Subject: Transmittal Letter – Errata and Addenda for Revision 1 of the April 2013 Mt. Taylor Mine Closeout Closure Plan and Revision 1 of the Application for Revision of Mine Permit to Active Status

ADDENDUM #1

APPLICATION FOR REVISION OF MINE PERMIT #C1002RE FROM STANDBY TO ACTIVE STATUS AND MODIFICATION OF GROUND WATER DISCHARGE PERMIT DP-61, MT. TAYLOR MINE, SAN MATEO, NEW MEXICO

**APPLICATION FOR REVISION OF MINE PERMIT #C1002RE FROM STANDBY TO
ACTIVE STATUS; MODIFICATION OF GROUND WATER DISCHARGE PERMIT DP-
61, MT. TAYLOR MINE, SAN MATEO, NEW MEXICO, REV.1, NOVEMBER 2013;
and**

Figure 1-6 Observation wells

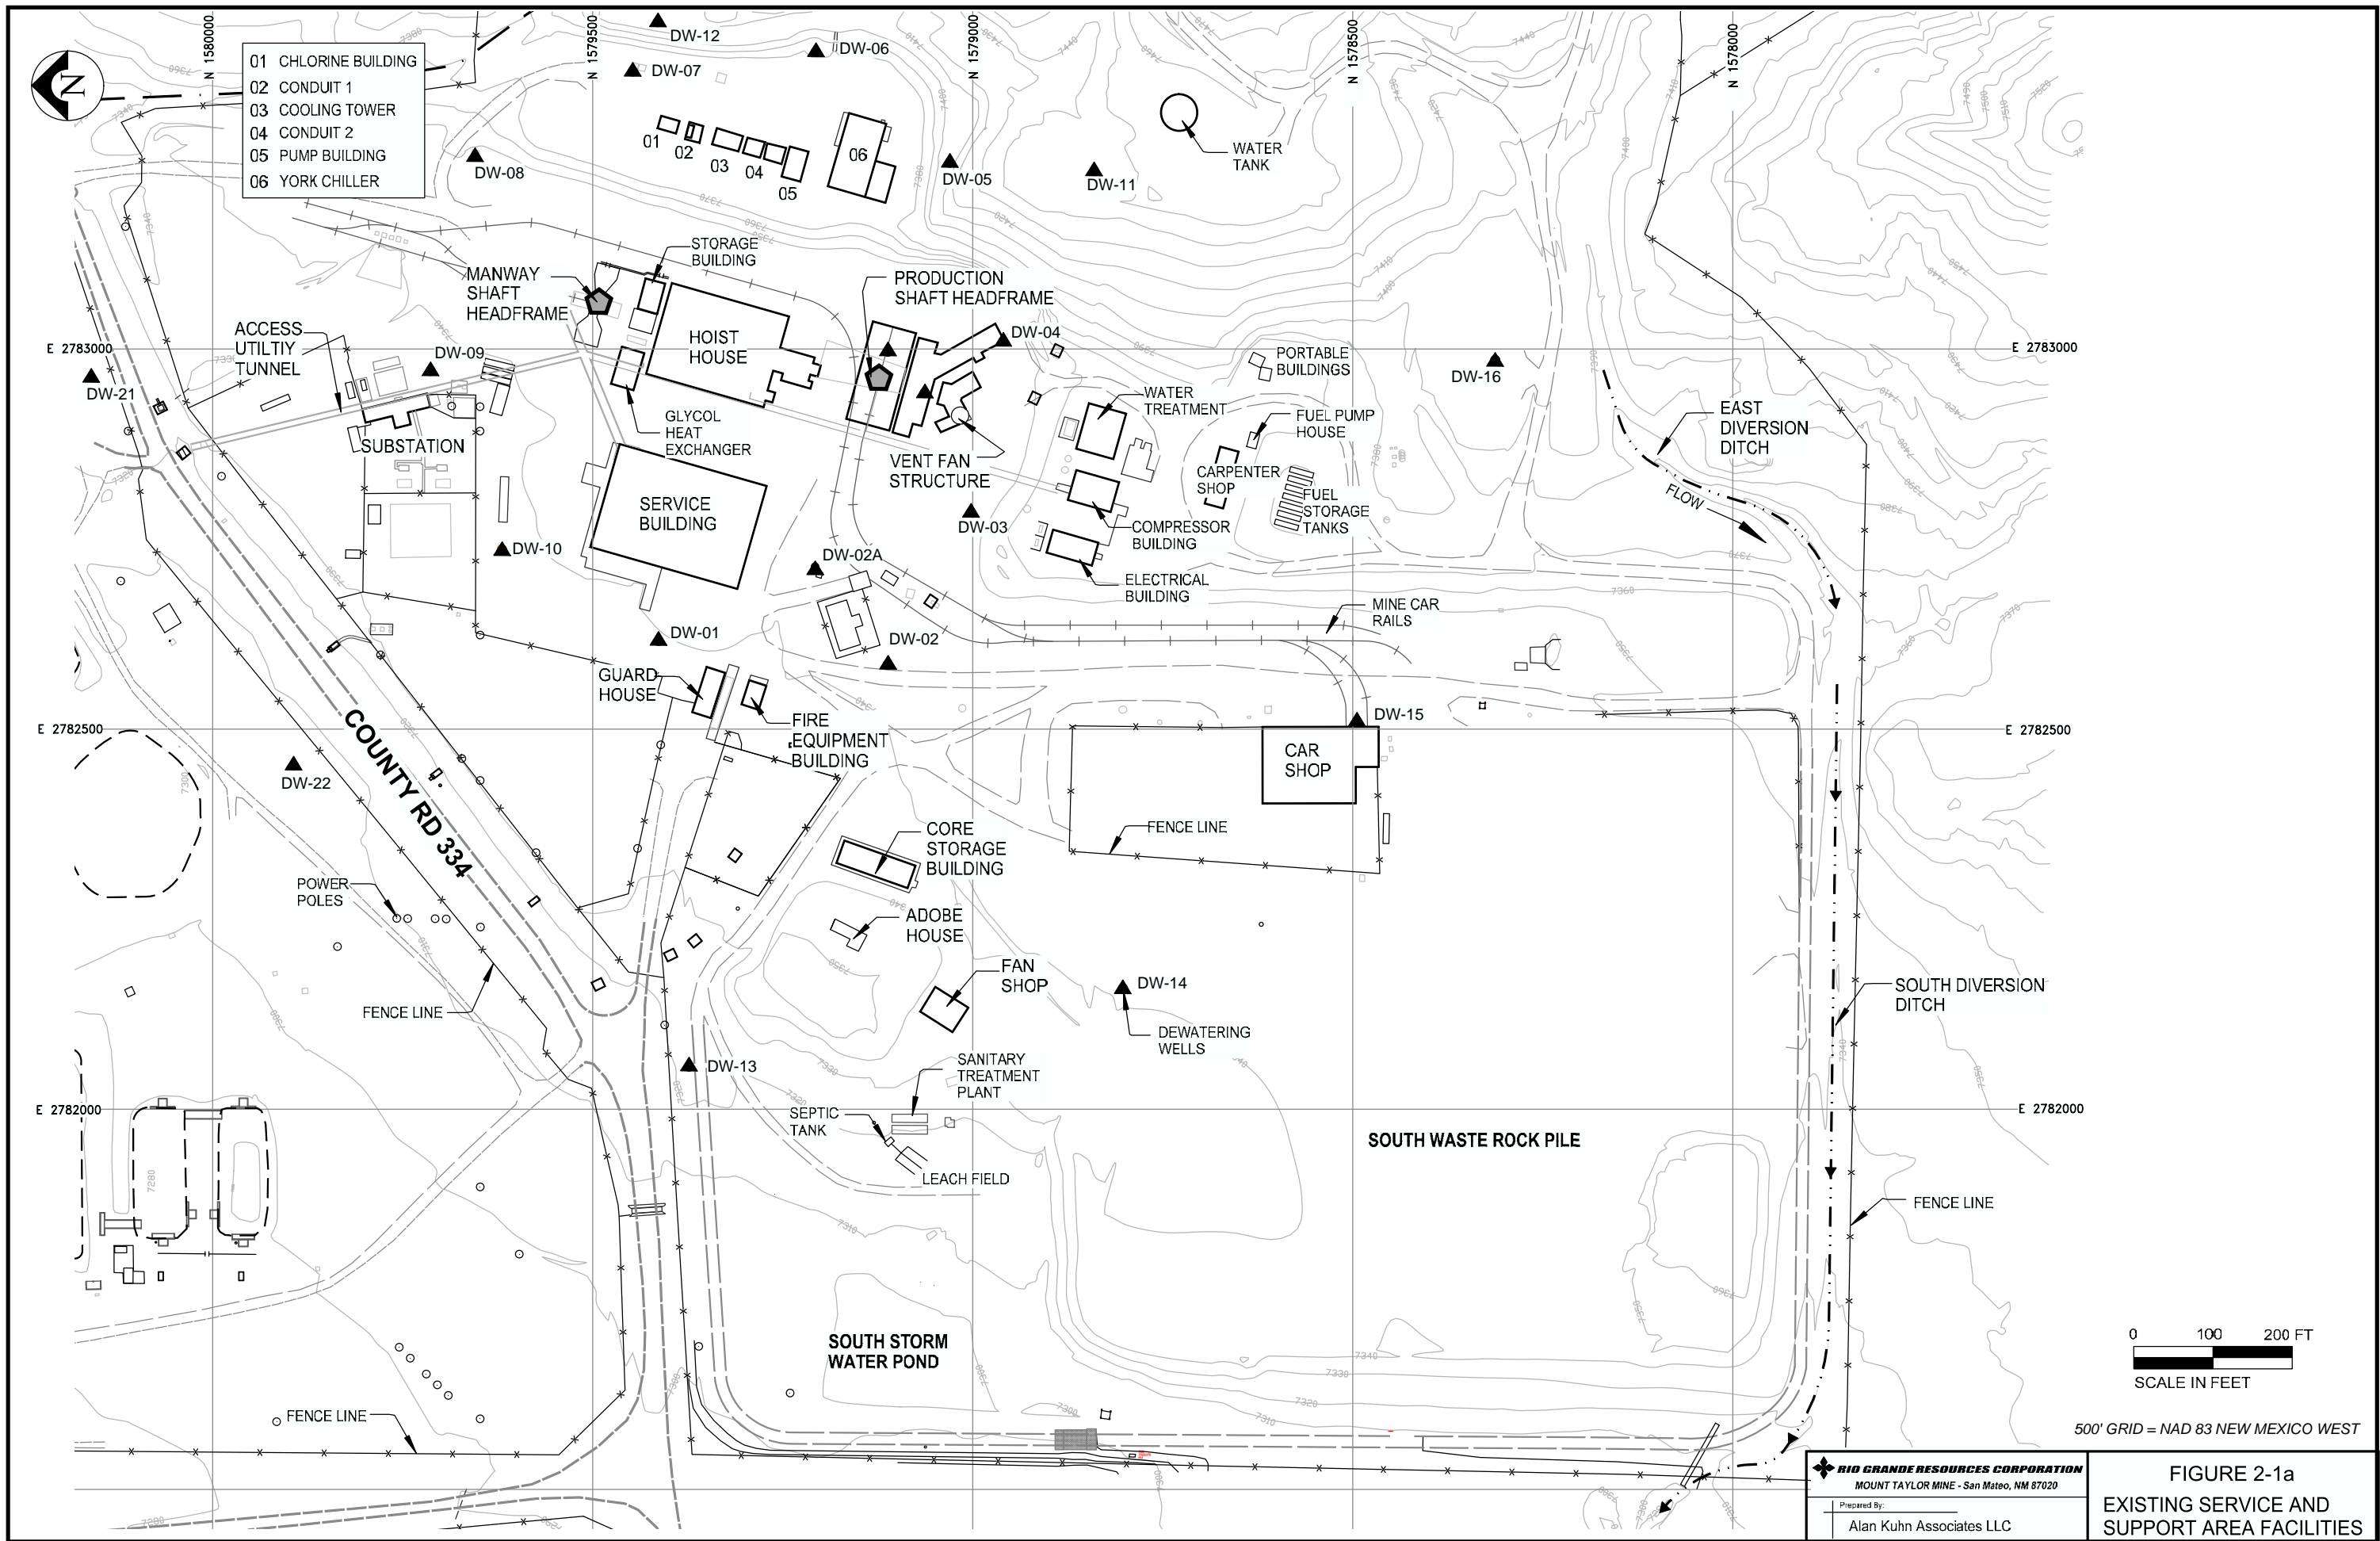
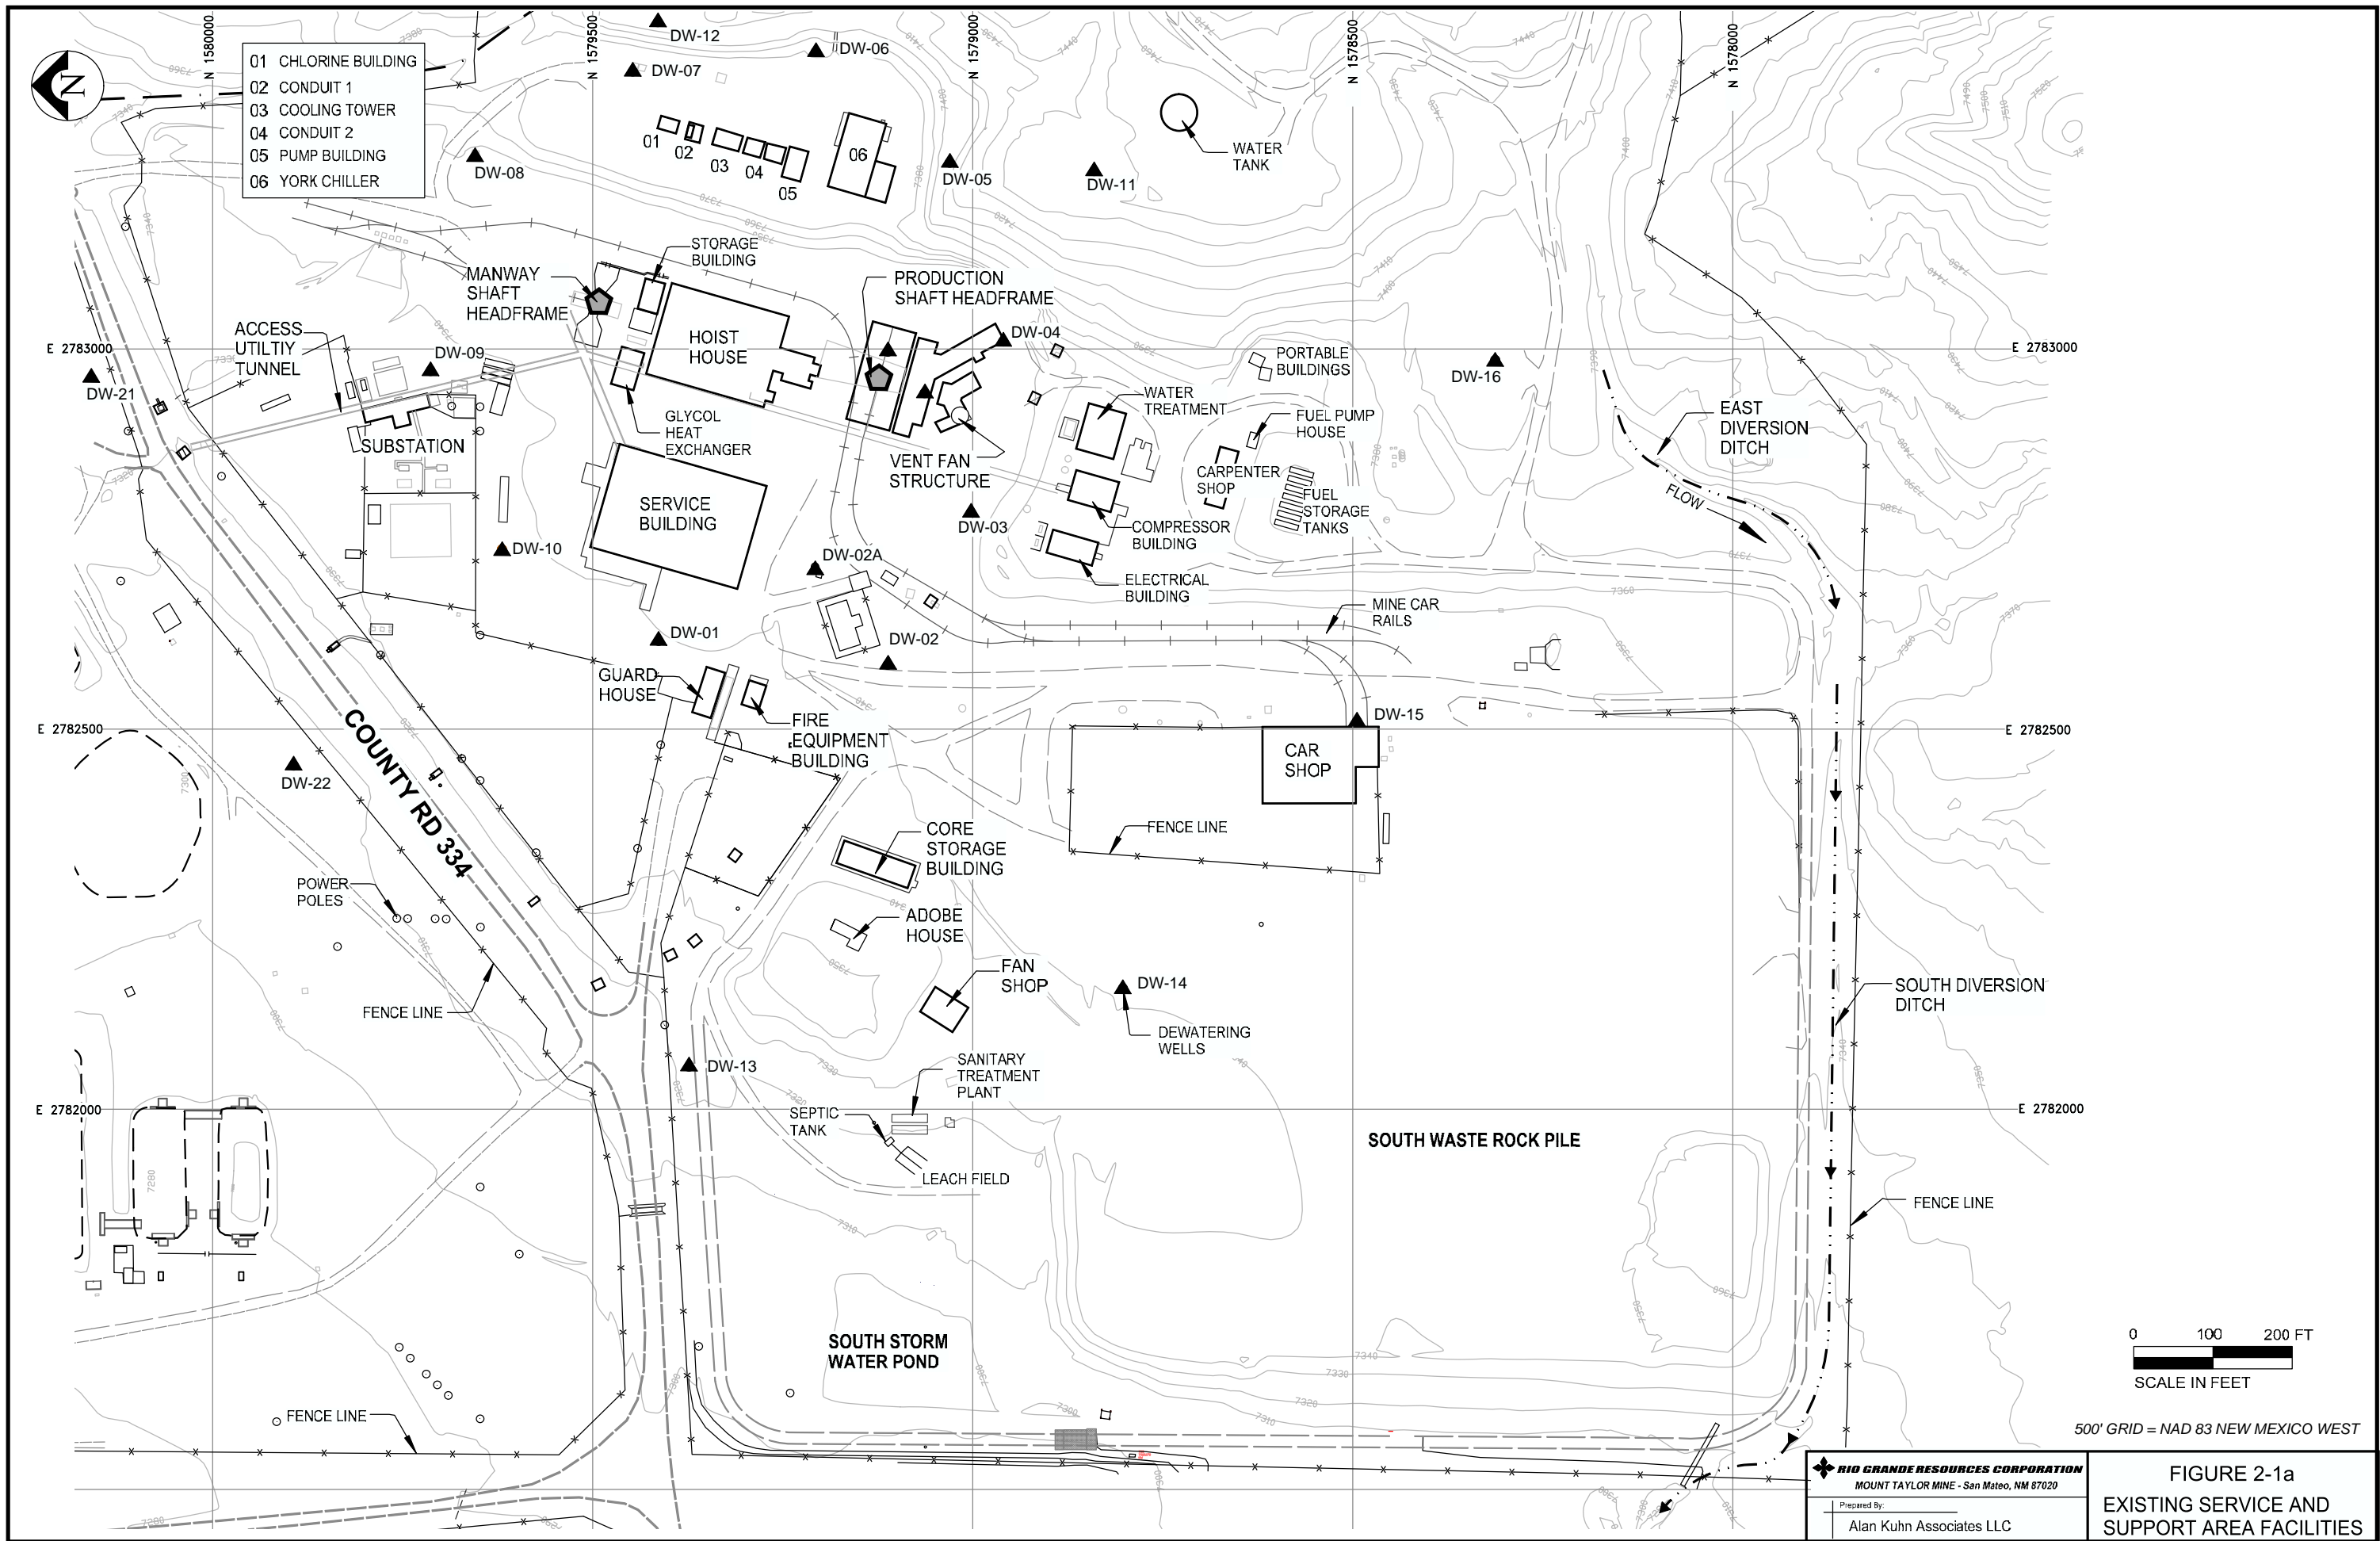
Figure 1-6
